PORTLAND PUBLIC SCHOOLS – FACILITY ADA ASSESSMENT

Gray Middle School 6-8
August 31, 2009

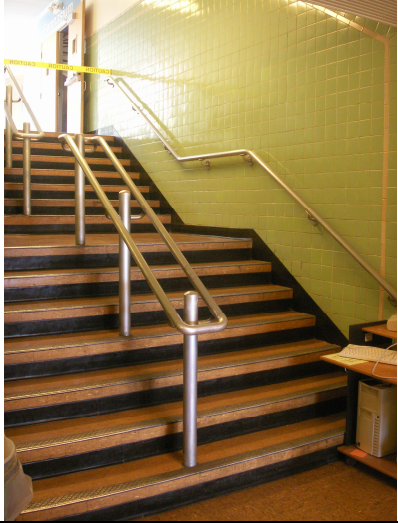
Entry, Accessible Southeast Doorway	<p>South end of covered entry canopy area has an increasing height curb and 2 unmarked steps to grade. Install handrails each side of stairs, both for stair safety, and also for visibility. Marked curb edge for visibility. Provide an accessible ramp (approximately 12lf.) Provide an accessible entry sign.</p>	
Entry Accessible Path	<p>Accessible path to east accessible front entry door crosses in front of 2 accessible stalls without pedestrian protection. Install wheel stops, at a minimum, or move vehicle parking out from covered pedestrian entry canopy.</p>	See picture above.
Pedestrian Accessible Path	<p>Paved pedestrian walk crossing small hill from SW Sunset Drive to SW 23rd Ave has steps down to SW 23rd with old metal handrails. Add handrail extensions. Beginning of path at Sunset Drive does not separate pedestrian traffic from vehicles, and is wide enough to be</p>
